**Clarksburg Fire Station #35, Forest Conservation Plan and Water Quality Plan, MR2012001**

**Clarksburg Fire Station #35, Forest Conservation Plan and Water Quality Plan, MR2012001**

- 23420 Frederick Road (MD 355)
- 3.99 Acres zoned R-200 in the Clarksburg Master Plan area
- Approval of a Final Forest Conservation Plan and Preliminary/Final Water Quality Plan for the construction of a new firehouse

**Figure 3: Plan View of Trees Requiring Variance**

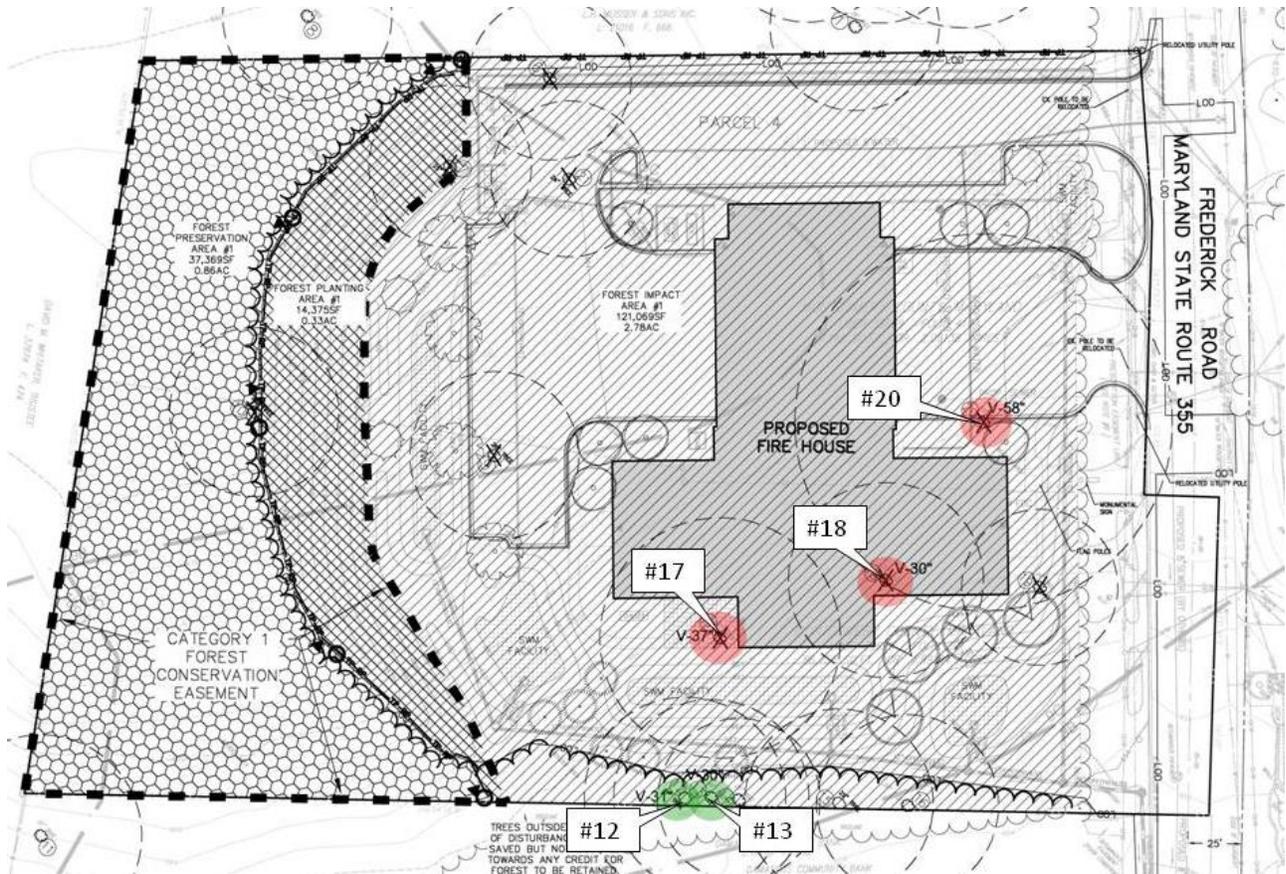
Section 22A-12(b)(3) of the County Forest Conservation Law identifies certain individual trees as high priority for retention and protection. Any impact to these trees, including removal of the subject tree or any disturbance within the tree’s critical root zone (CRZ) requires a variance. An applicant for a variance must provide certain written information in support of the required findings in accordance with Section 22A-21 of the County Forest Conservation Law. The law requires no impact to trees that measure 30 inches or greater, DBH; trees that are part of a historic site or designated with a historic structure; trees that are designated as a national, State, or County champion tree; trees that are at least 75 percent of the diameter of the current State champion tree of that species; or trees, shrubs, or plants that are designated as Federal or State rare, threatened, or endangered species. The applicant had submitted a variance request on August 12, 2011 for the impacts and/or removal of trees within the proposed limits of disturbance of the project (Attachment B). The applicant currently proposes to remove 3 trees that are 30 inches and greater, DBH, and to impact, but not remove, 2 others.

The applicant believes that the proposed development is situated in an area of the Clarksburg Master Plan that was identified for future development and that the site could not be developed as fire station without the removal/impacts to trees requiring a Variance. Staff concurs with the applicant’s assessment. The site cannot be developed as a functional fire station without the loss of, or impact to, the trees identified in this Variance. Efforts have been made to address tree impacts; however, the applicant has a sufficient unwarranted hardship to consider a Variance request.

Staff does not recommend that compensation be required beyond the reforestation requirement of the forest conservation plan for the proposed impacts to, or removal of, the 5 trees. All five of the affected trees are within the existing forest. As part of the forest conservation plan, the applicant is required to

provide reforestation to mitigate for the loss of forest. Part of this reforestation will be done on the site. Staff believes the required reforestation on the site will also mitigate for the loss of the 3 large trees in the existing forest and the impacts to the 2 others to remain. Additionally, Staff believes such impacts are due to necessary infrastructure and are unavoidable.
